PCN AMS-AAS/13/7931

**Additionnal Assembly site for ST8024LCDR Smart Card Interface**

**Additional assembly site for ST8024LCDR for AMS Group**

**SO-28**

Qualification program and results:

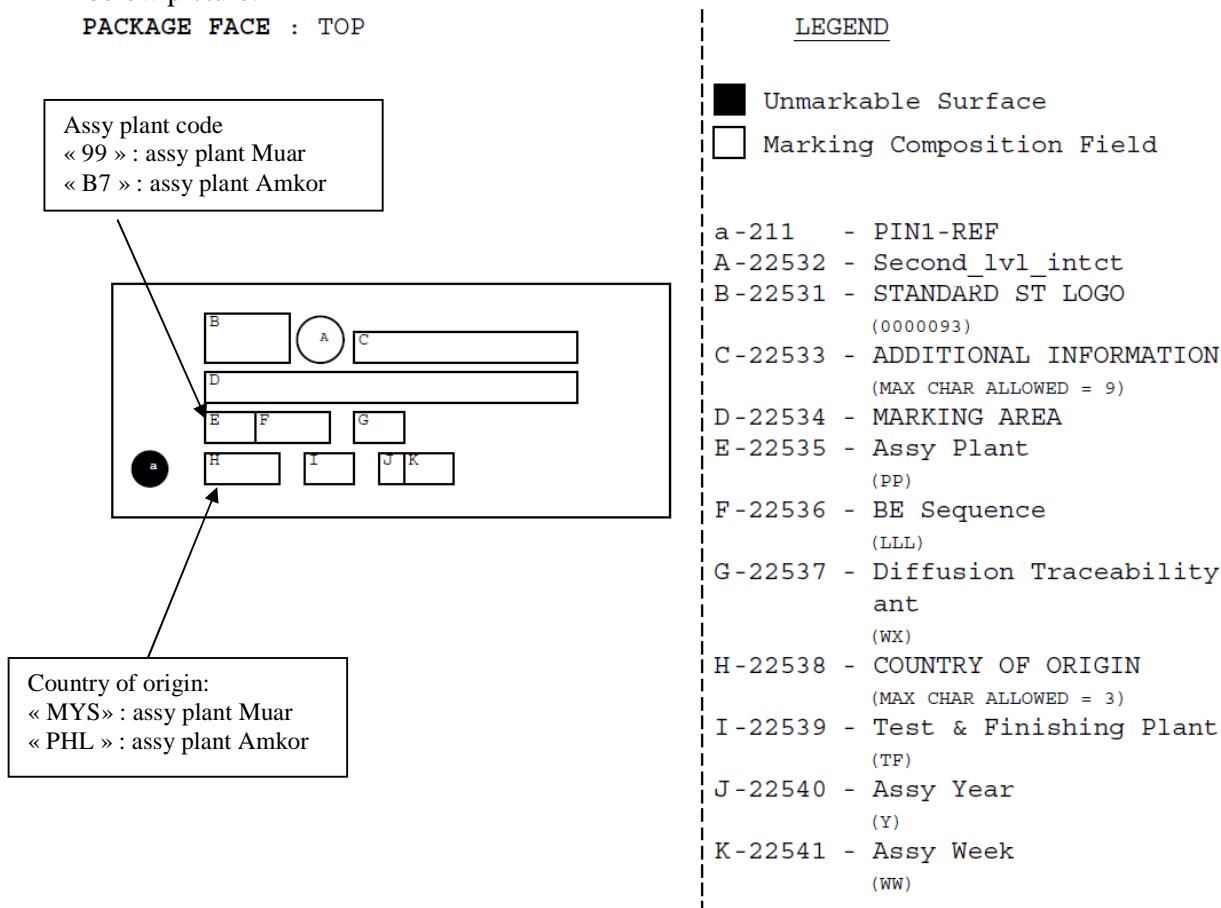
The change is already qualified through attached report.  
Here below you'll find the details of qualification plan.

The qualification program consists mainly of comparative electrical characterization and reliability tests. Please refer to Appendix 1 for all the details.
